# TERAFLEX

## Technical Service Bulletin JK HD Ball Joint Kit 2013+ JK Stub Shaft Modification

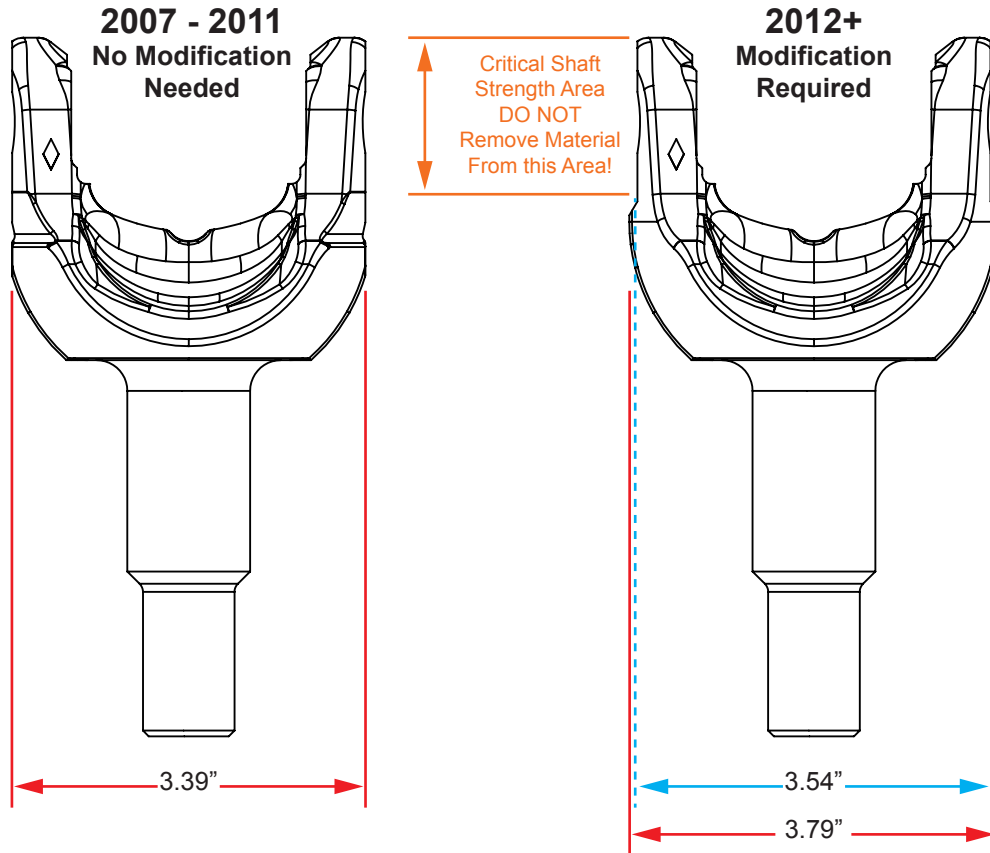
2012 and newer front Dana 30 & Dana 44 equipped JK Wranglers utilize a larger diameter outer stub shaft. This causes interference issues when used with TeraFlex HD Ball Joints (lower ball joint only).

A DIY solution to fix this issue involves minor clearancing of a non-critical area of the outer stub shaft to allow proper lower ball joint clearance. As seen in the diagram above, removal of approximately 0.125" from each side of the outside diameter of the outer stub shaft shoulder is required.

Note: By avoiding any modification to the critical strength area, shown above, the outer stub shaft's performance and strength will not be affected by this slight modification.
